Notice of Allowability

10/790,194

BELKE ET AL.

Examiner's Amendment

FIG. 2A (PROPOSED)

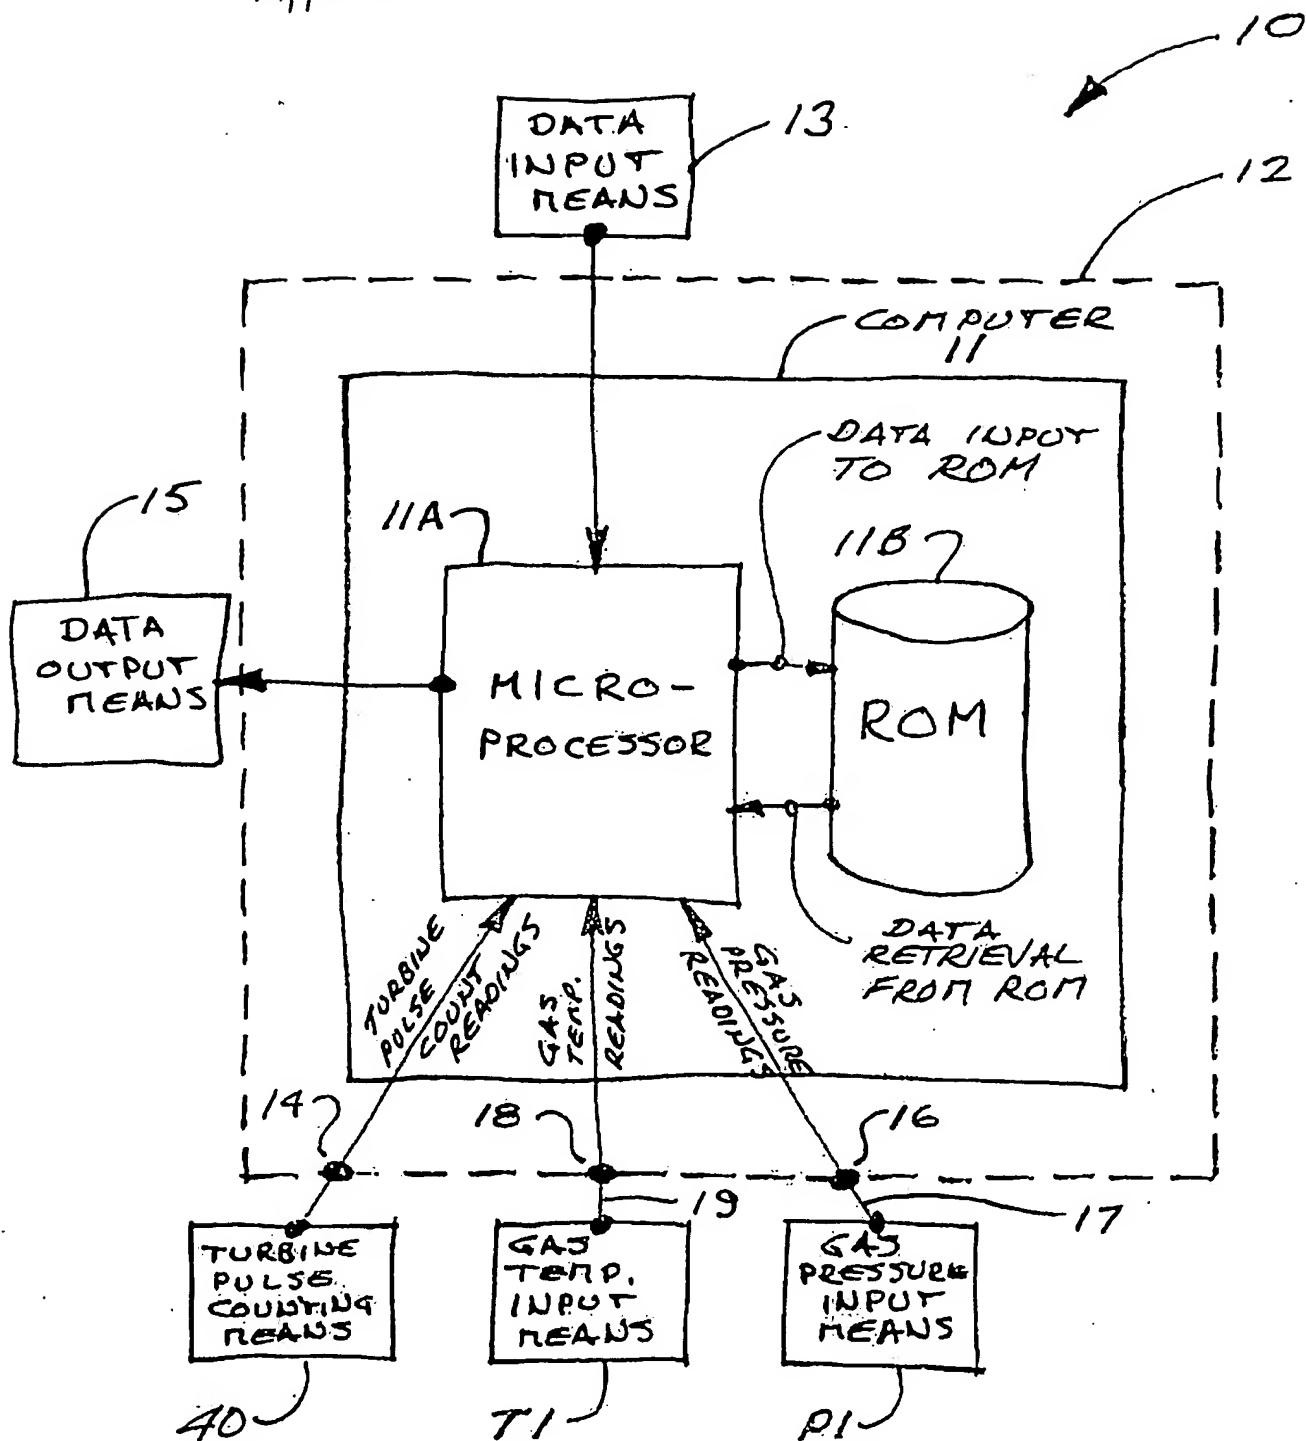
New Figure:

Insert new FIG. 2A (See attached proposed drawing).

New paragraph:

Page 10, Line 9. Insert the following paragraph:

FIGURE 2A is a block diagram of the computer of an electronic gas flow measurement device in accordance with an embodiment of the invention.
